# KEFORD COLLISION AND TOWING JSP 18-31

Public hearing at the request of Keford Collision & Towing for Planning Commission's approval of the Preliminary site plan, Wetland permit, and Storm water management plan. The subject property is currently zoned I-2 (general industrial) with an associated planned rezoning overlay (PRO) agreement. The subject property is approximately 7.61 acres and is located on the south side of Grand River Avenue between Taft Road and Novi Road (Section 15). The applicant proposes to use the existing larger building for an auto body collision repair shop and related offices, along with an accessory use of car rental services. No particular subtenants for the second existing building have been identified yet. The plan proposes an enclosed yard of up to 160 spaces in the rear yard for storage of towed vehicles.

# PLAN REVIEW CENTER REPORT

**Review Date:** October 07, 2019  
**Review Type:** Preliminary Site Plan  
**Project Name:** JSP 18-31 Keford Towing  
**Plan Date:** September 12, 2019  
**Prepared by:** Sri Komaragiri, Planner  
**E-mail:** skomaragiri@cityofnovi.org; **Phone:** (248) 735-5607

**PRELIMINARY GRADING PLAN**

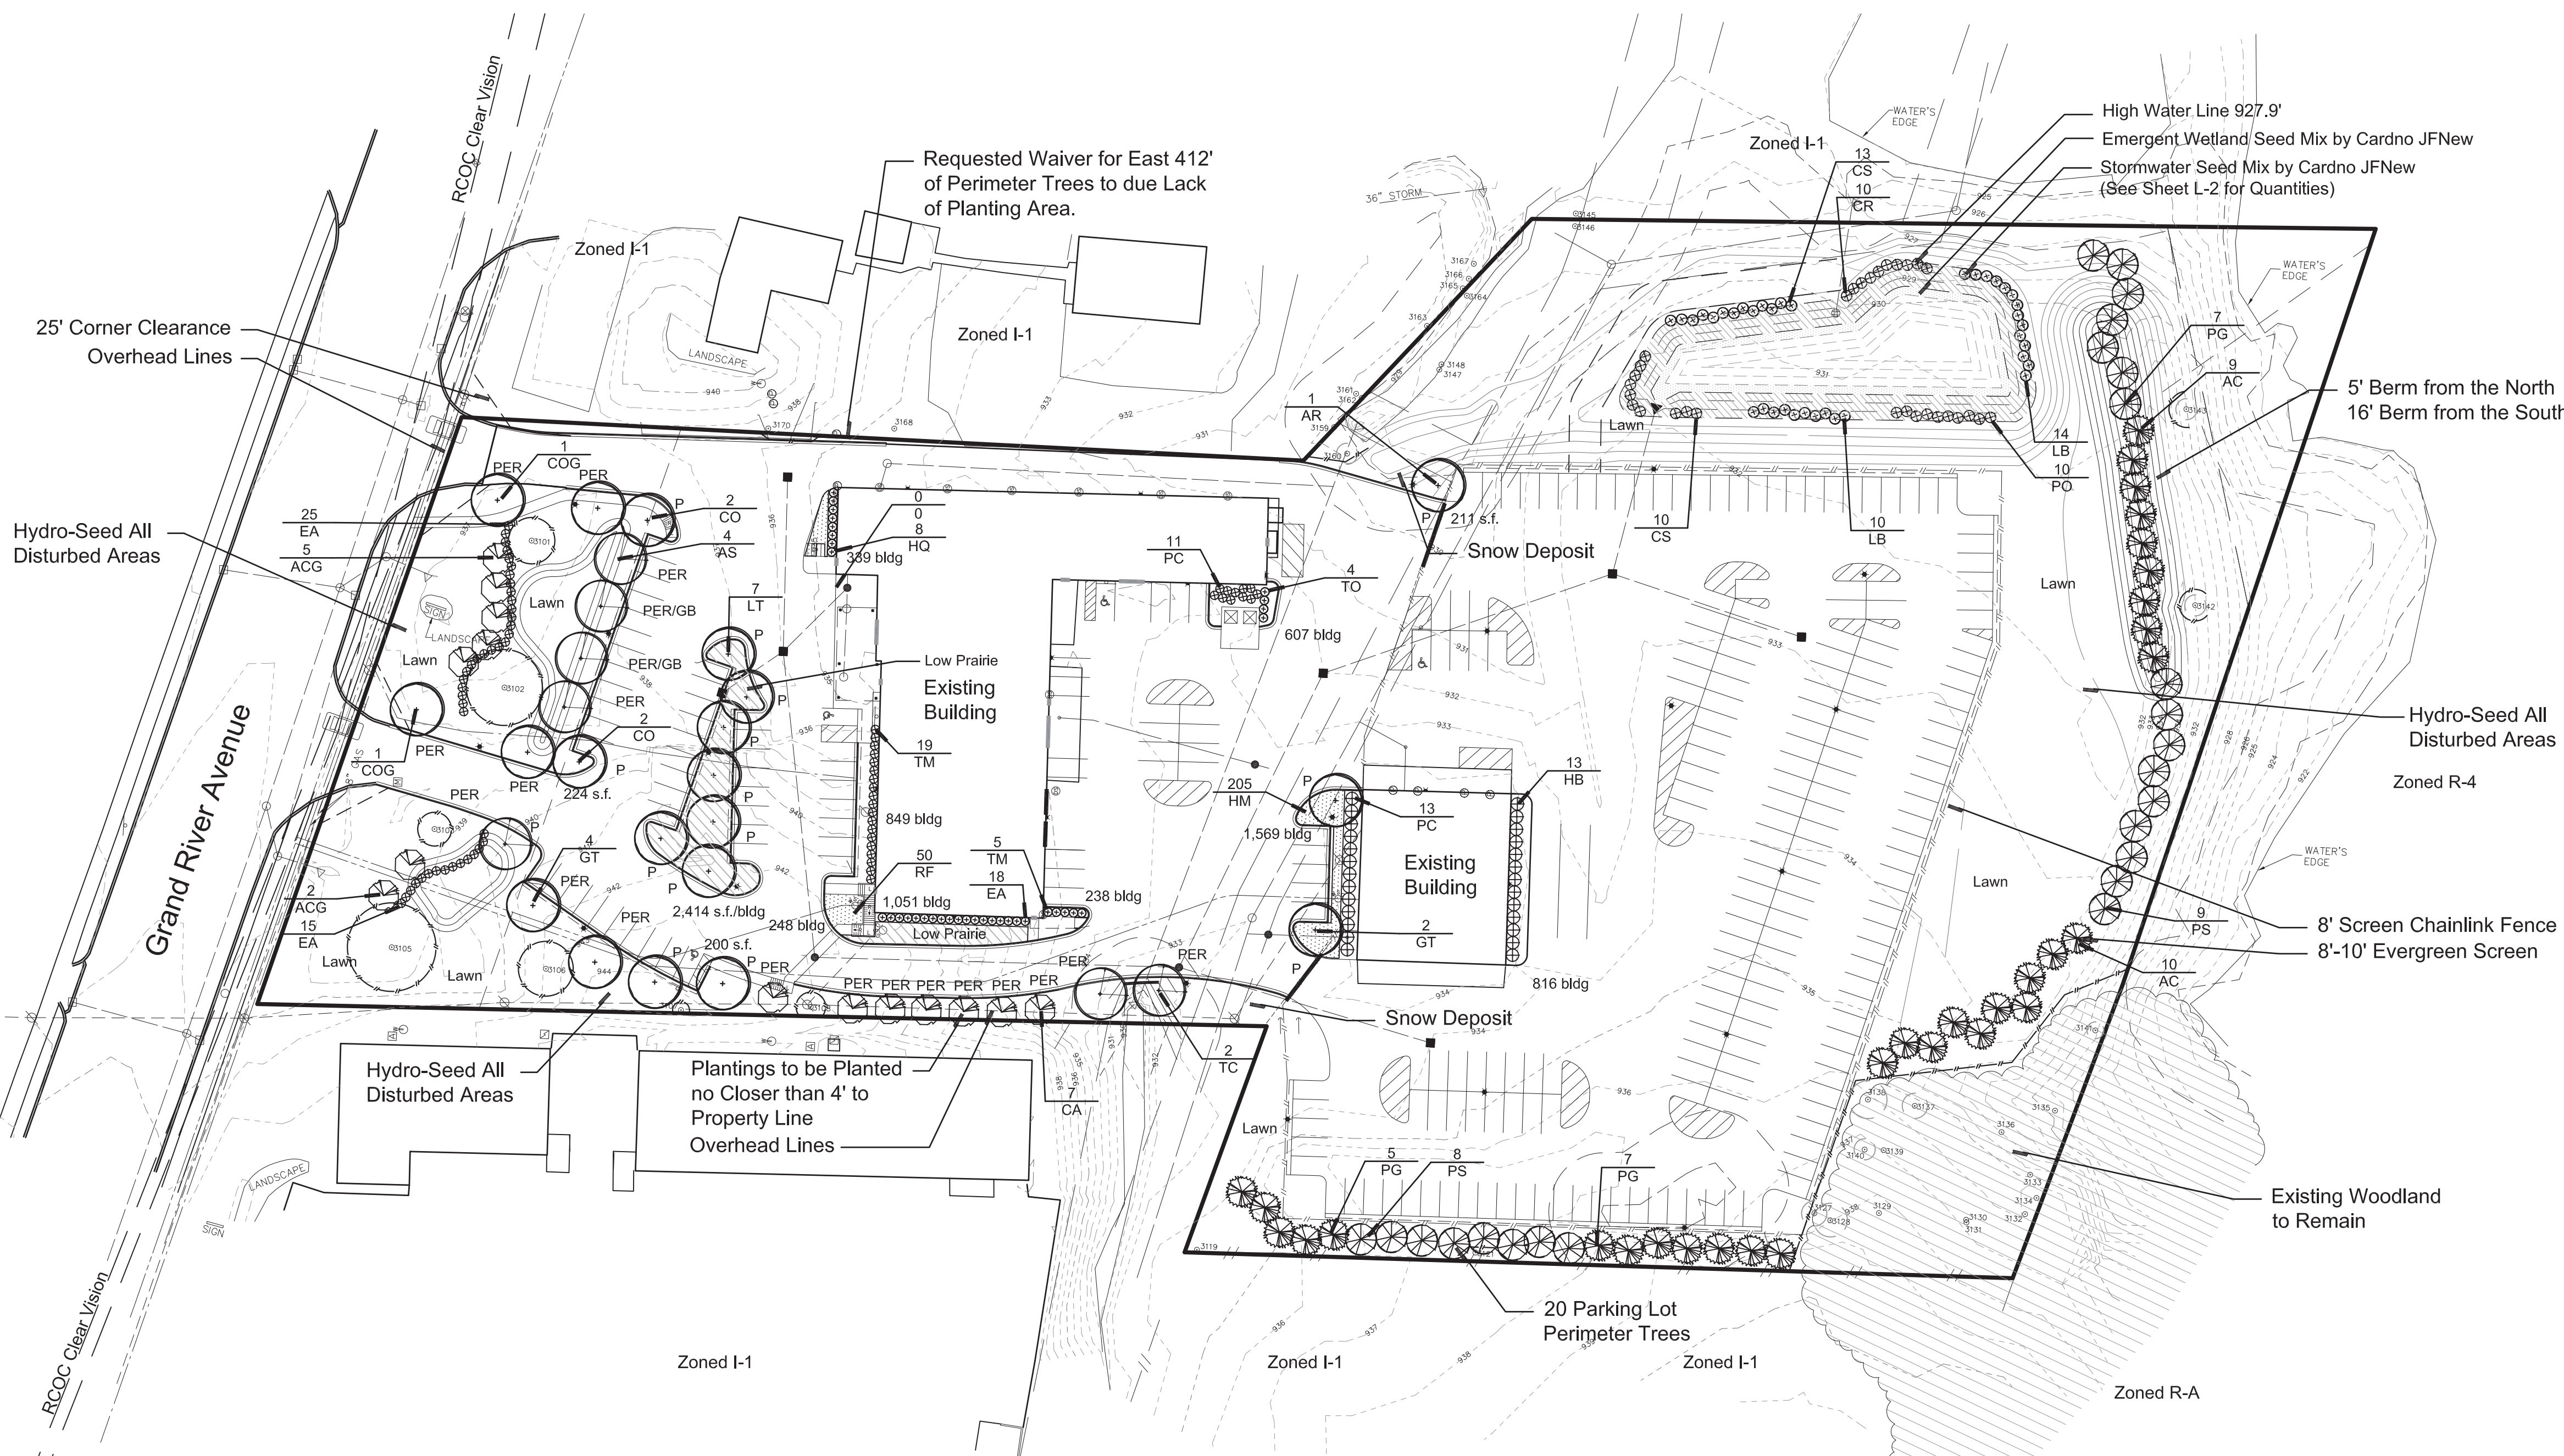
The following table summarizes the proposed wetland impacts as listed on the *Preliminary Grading Plan* (Sheet 3):

***This comment has not been addressed. All impacts on the Preliminary Grading Plan (Sheet 3) appear to be permanent, however a Low Prairie Seed Mix is proposed on the Landscape Plan (Sheet L-1). It is not clear where this particular seed mix is proposed to be installed. Please review and revise the Plan as necessary.***

**Landscape Plan**

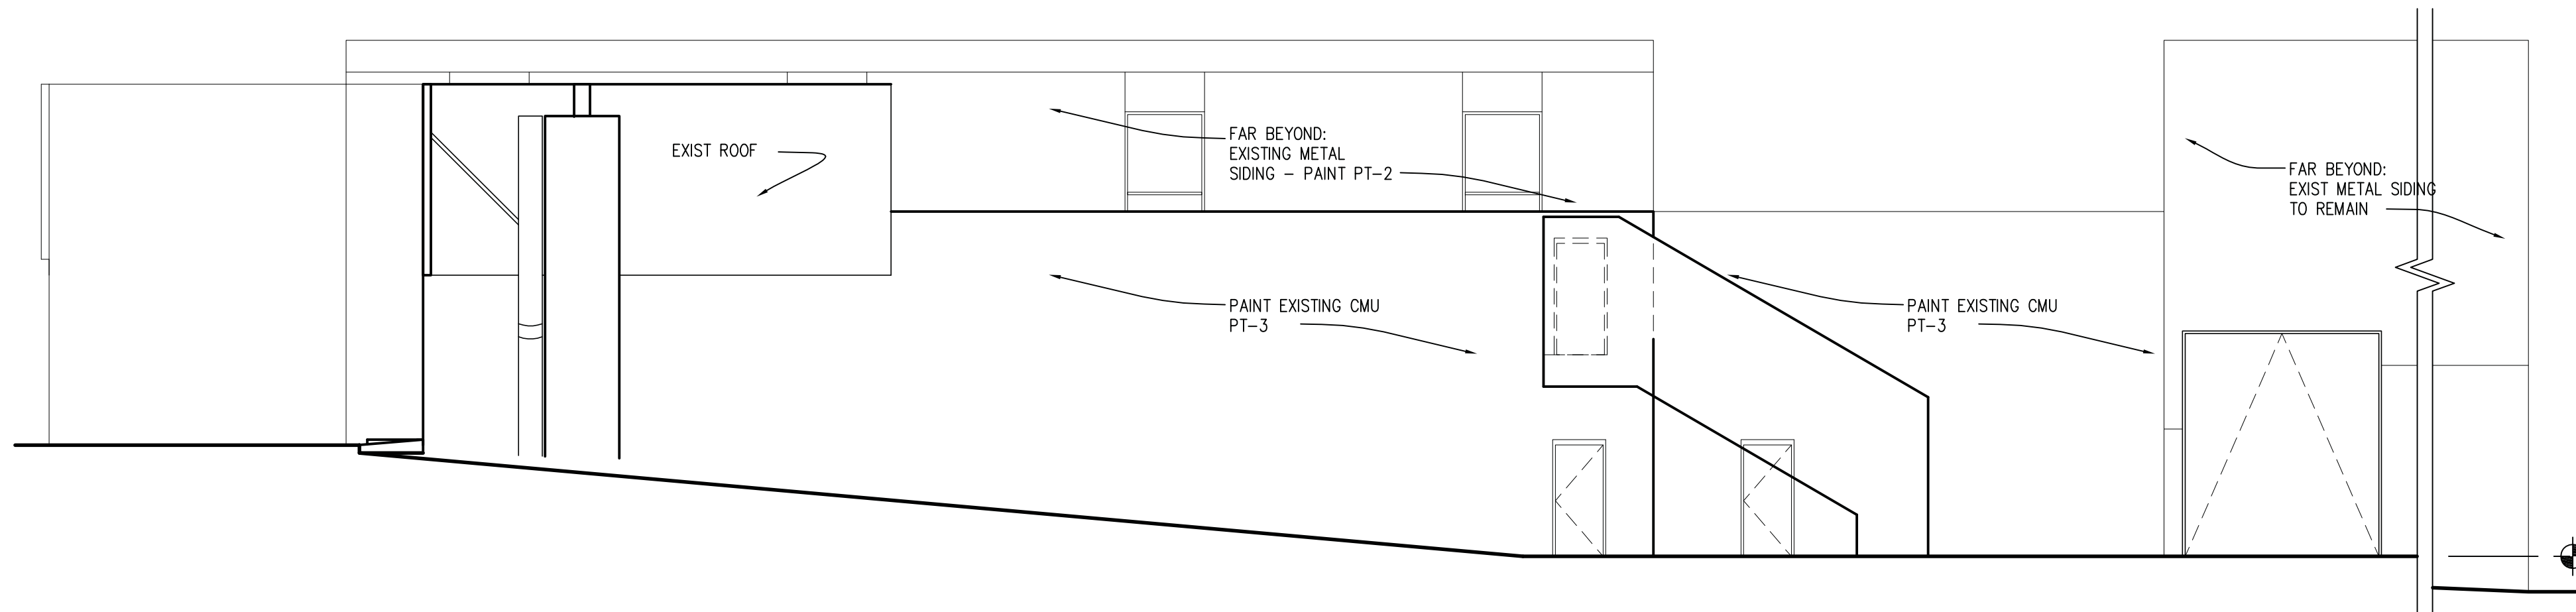
**Please copy the above, including the meeting date, to Sheet L-1 in place of the other text regarding waivers.**

- The landscape waivers, including the meeting date, will be shown on Sheet L-1.
- An additional evergreen tree species will be used.
- An irrigation plan will be submitted with Stamping Sets.

**sheet title**  
**EXTERIOR ELEVATIONS**  
DO NOT SCALE DRAWINGS  
USE FIGURED DIMENSIONS ONLY

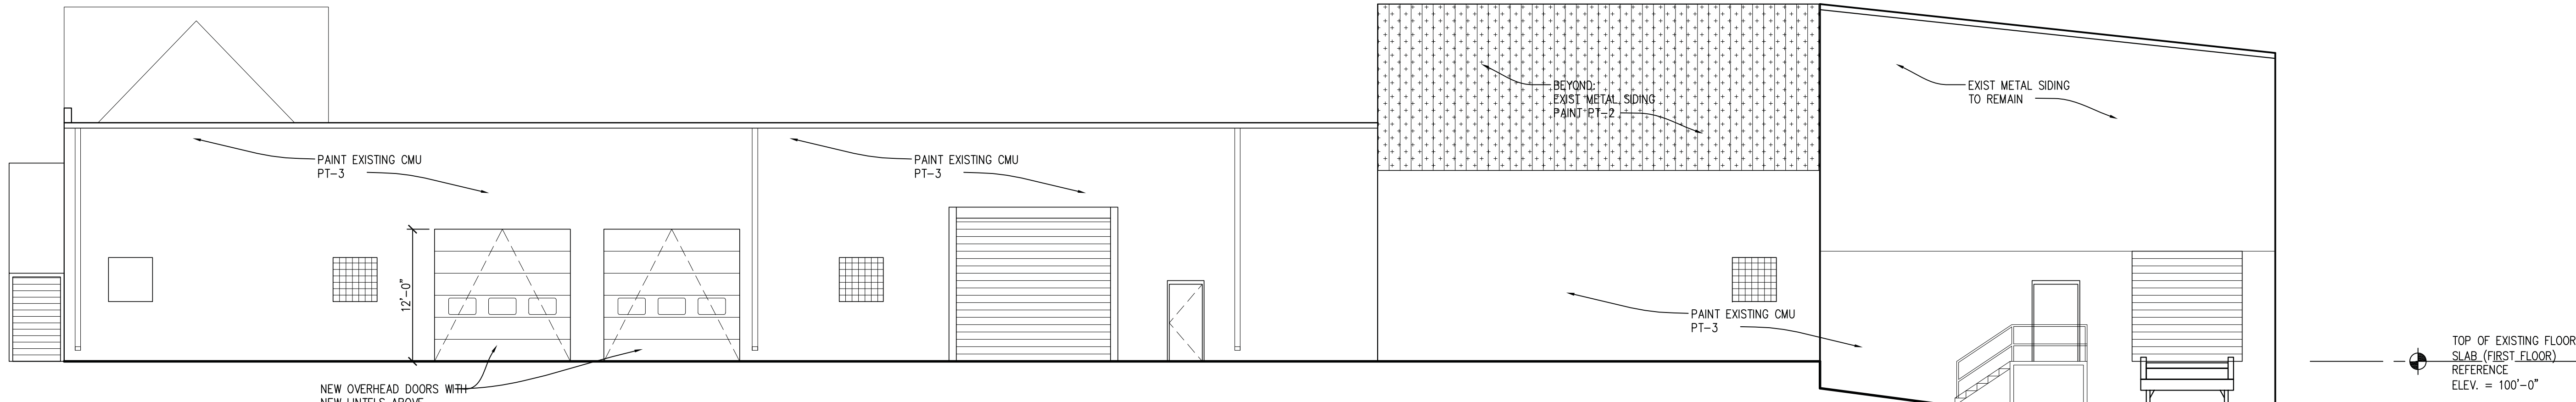
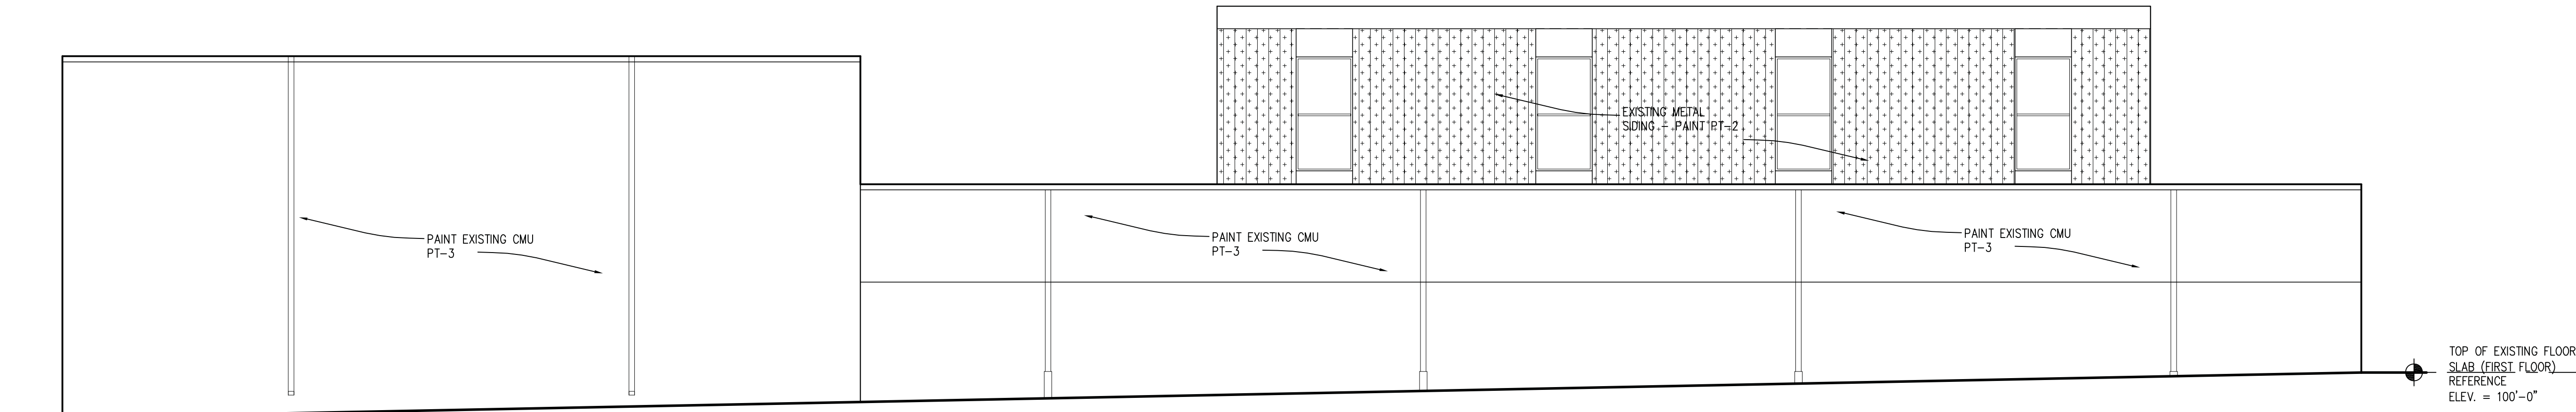
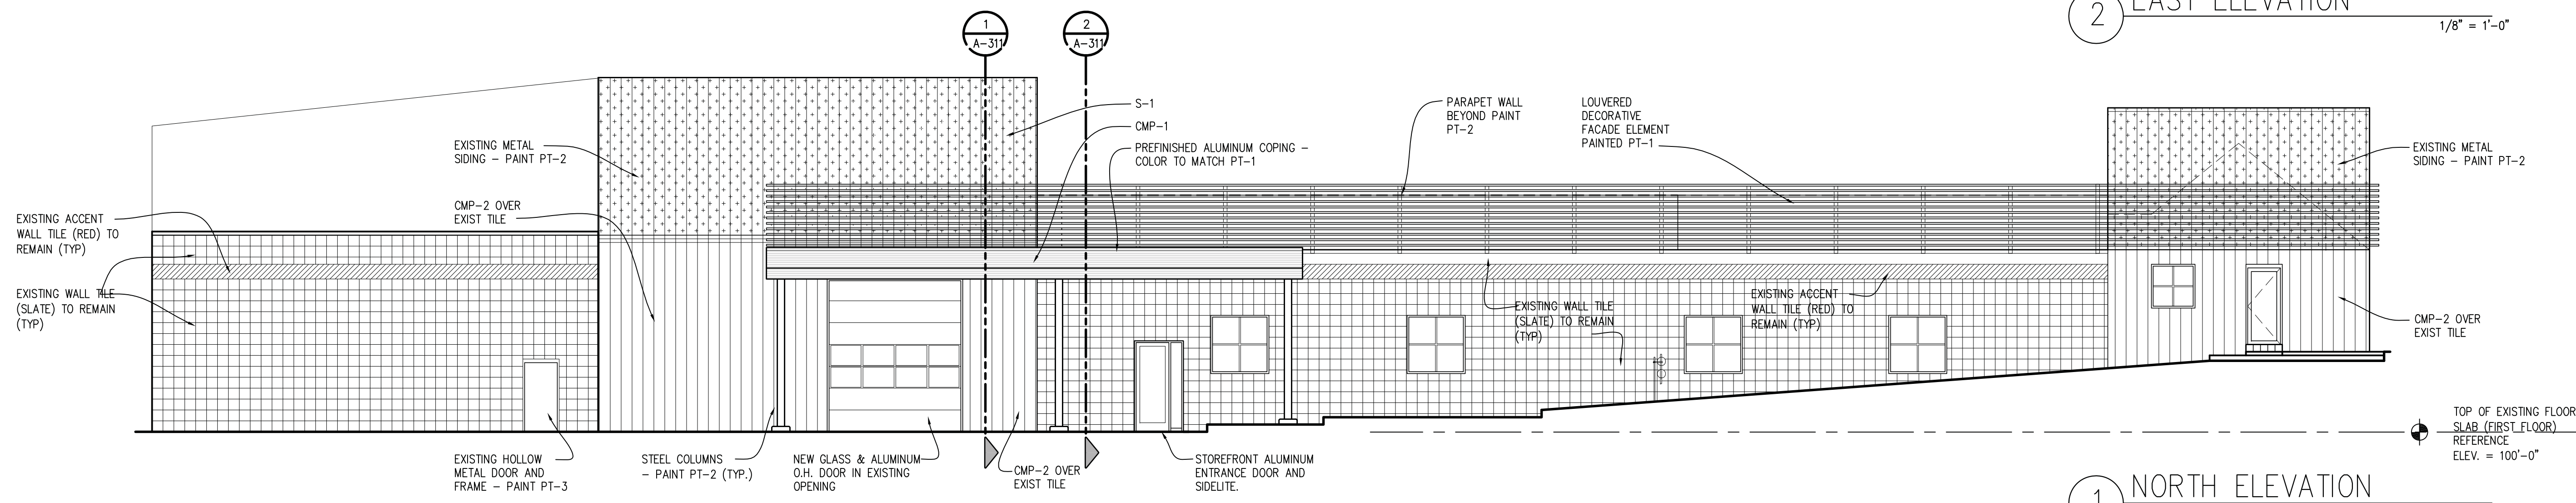
- a. The color proposed for the louver feature and the accent band (SW6868 Real Red) is not consistent with Section 5.15.2 of the Façade Ordinance which prohibits intense colors. **Please work with our façade consultant to find a compatible red.**
- b. The façade materials on the side and rear elevations are not proposed to be changed. The PRO approval for the front façade was contingent on the side and rear elevations be painted or otherwise treated in a manner that is consistent with the front façade and that the existing natural fired clay tile will not be painted. **Please provide revised side and rear elevations as noted.**

**Please submit revised elevations addressing comments in Façade review letter.**
